# RENESAS TECHNICAL UPDATE

Product Category	MPU/MCU		Document No.	TN-RX*-A0242B/E	Rev.	2.00
Title	RX21A Group, RX220 Group Errata to User's Manual: Hardware Regarding the Realtime Clock (RTC)		Information Category	Technical Notification		
Applicable Product	RX21A Group, RX220 Group	Lot No.	Reference Document	RX21A Group User's Manual: Hardware Rev.1.10 (R01UH0251EJ0110) RX220 Group User's Manual: Hardware Rev.1.10 (R01UH0292EJ0110)		
		All

This document describes corrections to the "Realtime Clock (RTC)" chapter in User's Manual: Hardware for the applicable products.

Figure 26.3 Clock and Count Mode Setting Procedure

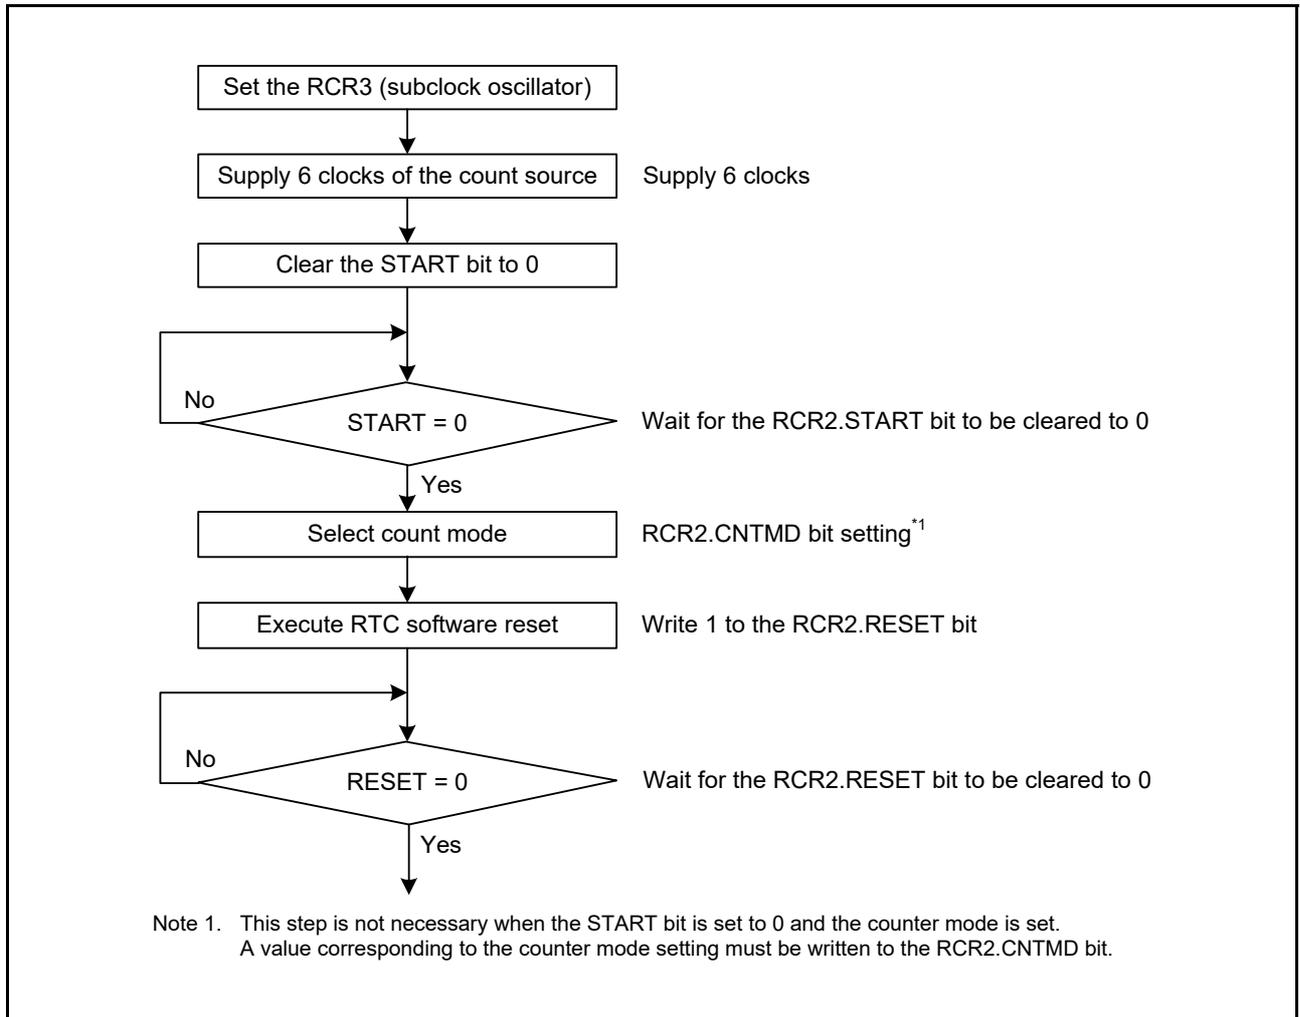
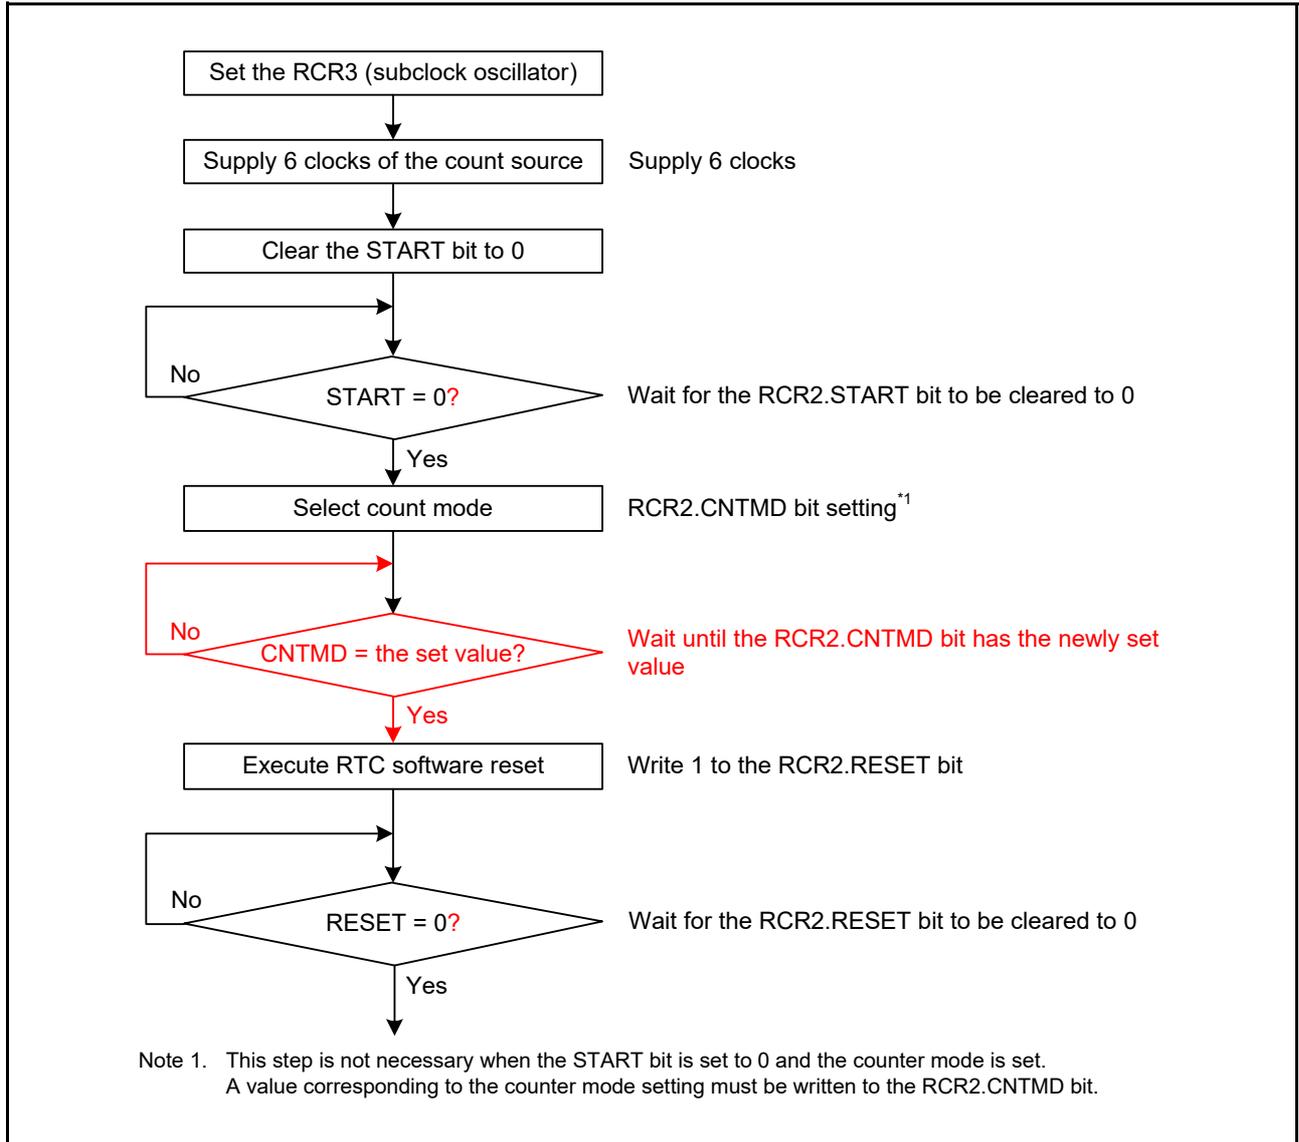
The setting procedure described in Figure 26.3, Clock and Count Mode Setting Procedure is corrected as follows.
